STAFF REPORT

PRELIMINARY PLAT HERITAGE PEAKS SUBDIVISION

Prepared February 28 for the March 9th, 2011
Planning & Zoning Commission Public Hearing

The areas colored blue would be inundated by 100-year flood events

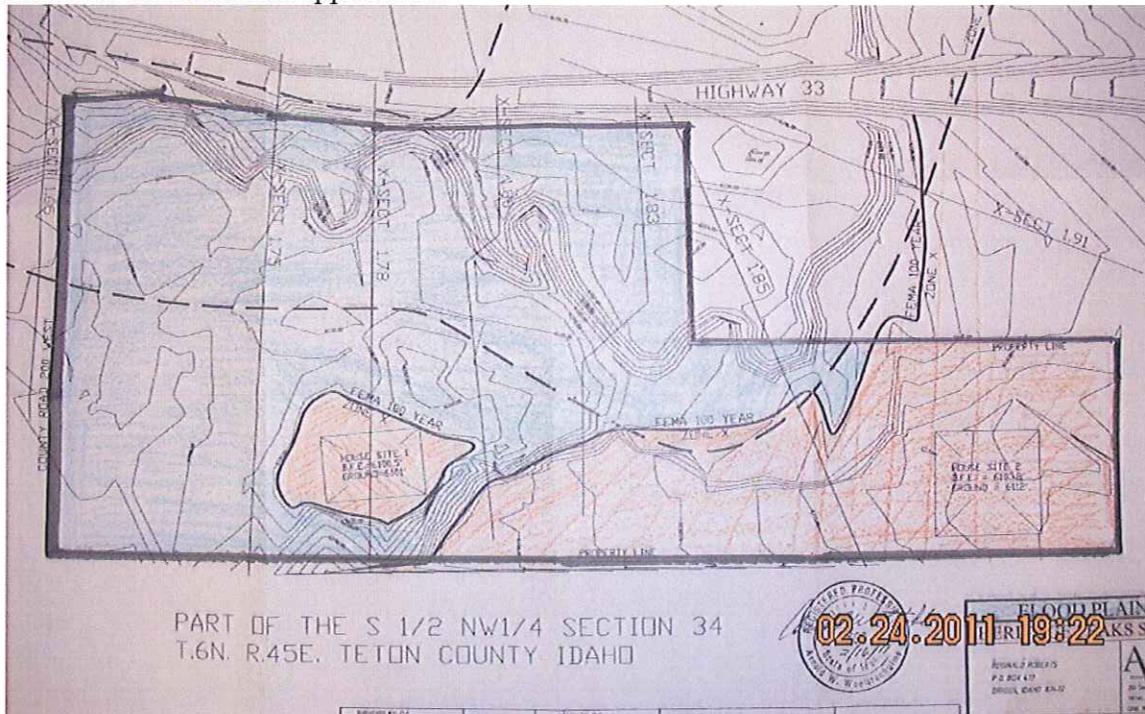
- The conclusions and findings within the Heritage Peaks Floodplain report and comment letters from the Floodplain Administrator are attached to this report. The roughly mapped FEMA floodplain was actually enlarged as a result of more precise watershed calculations. The floodplain report has not yet received final acceptance by the County, so Staff suggests a recommended Condition of Approval that the base flood elevations be accepted by the County Floodplain Administrator prior to the Board's consideration of the Final Plat application.

- The building envelope for Lot 1 lays a mere half-foot above the estimated 100-year flood elevation and it is surrounded by areas of 100-year flooding. Given this, the building code requires a vertical separation distance of at least one-foot between the base flood elevation and the habitable floor, and also dictates certain construction designs and eliminates the slab-on-natural grade design option. In other words, a residence constructed on building envelope #1 will need to conform to the National Flood Insurance Program standards. This may mean mounding up the Lot 1 envelope or using an elevated foundation. Staff is recommending a condition of approval for this project that the architectural-construction methods required in a floodplain area be disclosed in a document that a prospective buyer will likely encounter such as the CC & R and the recorded Master Plan.

Floodplain as coarsely mapped on the property site plan and the FEMA map.

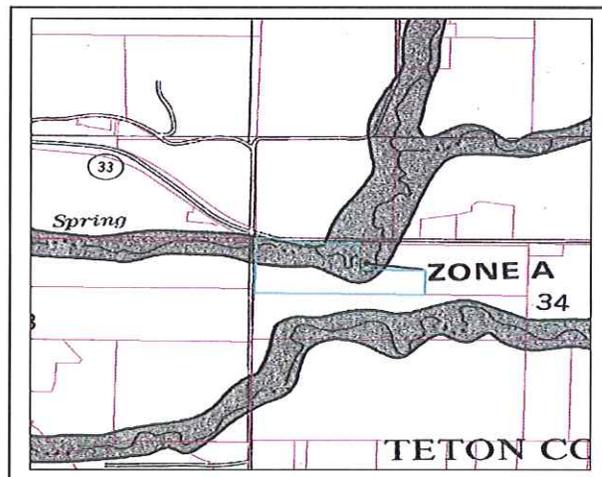
- 1) The National Flood Insurance Program requires that base flood elevations (BFE) be determined when a proposed subdivision has Zone A mapped on it. Proposed subdivisions (within communities participating in the National Flood Insurance Program) that have more than five (5) acres or 50+ lots must establish BFE at the subdivision stage rather than putting off these determinations to individual lots owners after platting. The type of engineering methods available for estimating the location of the 100-year floodplain (1% annual probability flood event) are specified by FEMA, but there is some discretion allowed for the floodplain administrator.

- 2) AW Engineering submitted a BFE determination/ floodplain report and the building envelopes are shown outside the floodplain. However, there are vertical separations required between the high water and habitable floors and this is an issue at the building permit stage. Staff recommends disclosing these requirements in the subdivision documents that a prospective buyer would easily find.
